出張先 Customer	PANASONIC TIANJIN	相手先 面談者 Attendance	Mr Matsumoto – PID QA Ms Pei – Buyer Mr Zhan – Production Engineer
出張目的 Visit Purpose	☒ ALT10PKB – Double slit ☒ Crack improvement ☒	会議フロア アップ項目 Meeting Follow Up	☒ As attach in below table ☒ ☒

1. ALT10PKB – Double slit

Detected double slit at this area

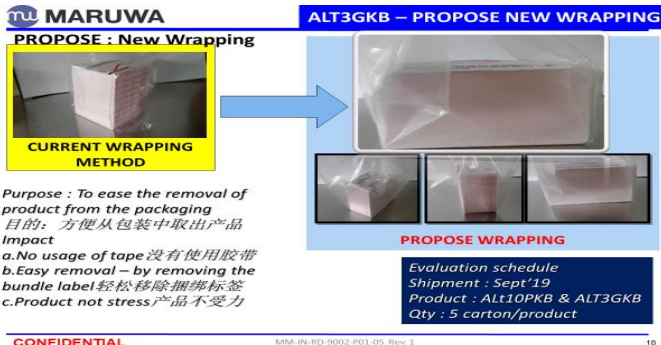
Detected new cases of double slit and MM need to confirm the effected lot from Apr'19 shipment up July'19 shipment

Due to this occurrence ==> PID will sort out the double slit area and continue using the balance product

=> Fear of flow out of double slit product
